DART AEROSPACE LTD	Work Order:	112779
Description: Crosstube Assembly (205/212 High Aft)	Part Number:	D212-664-241
Inspection Dwg: D212-664-241 Rev: D		Page 1 of 2

DRAWING NO. D212-664-241	TITLE CROSSTUBE ASSY (205/212 HI AFT)	REV. D	DART AEROSPACE LTD ENGINEERING ORDER		D.E.O. NO. D212-664-241-D-1	SHEET NO. SHEET 1 OF 2	SCALE NTS
DRAWN	CHECKED		MFG. APPR.		APPROVED	DE APPR.	
DATE 11.04.07	DATE 11.04.11		DATE 11.04.12		DATE 11/04/12	DATE 11.04.12

PURPOSE:

ADD AN INSPECTION WINDOW TO UNDERSIDE OF CROSSTUBE.

**D212-664-241/-241B
ASSEMBLY DETAIL**

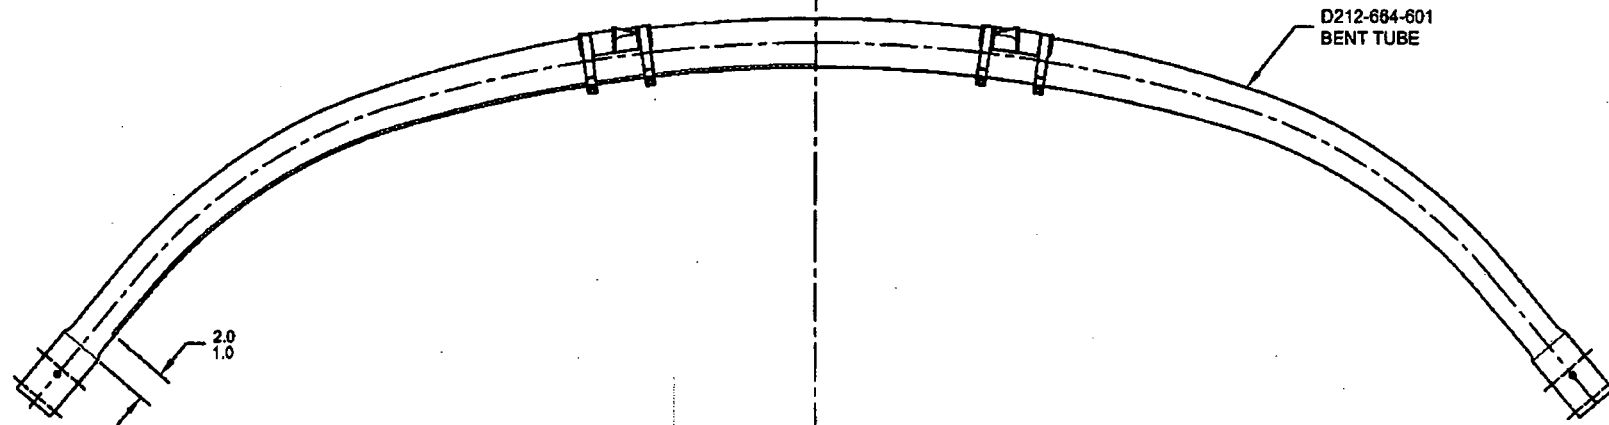
IS:

WAS:

MASK AREA PRIOR TO PAINTING,
REMOVE MASKING AFTER PAINT
AND APPLY CLEAR COAT
